Philadelphia Electric Company's  
Peach Bottom Atomic Power Station  
Control Room Design Review Final Report

February 28, 1986

#8

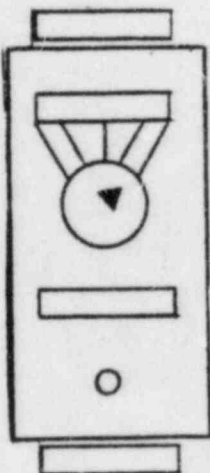
Controller labels do not clearly specify what a change in output will do to the process being altered. See attached.

Large knob with three positions labeled Auto, Balance, Manual. Appears to be a dual function knob; second function not identified.

Scale above controller 0-1.0, no units function not identified.

Scale with center marked 0, no units, function not identified.

Controllers will be labeled to clearly indicate what a change in output will do to the process being altered.

#11

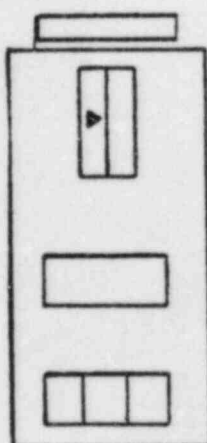
Similar to #7 except knob has five positions: 0-100, Auto, Balance, Manual, 0-100.

Scale above controller 0-100, no units, no function identified.

Left scale has pointer, no graticules, no numbers, no function identified. Right scale 0-16 with units indicated, no function indicated. Knob to left of scales labeled "SP."
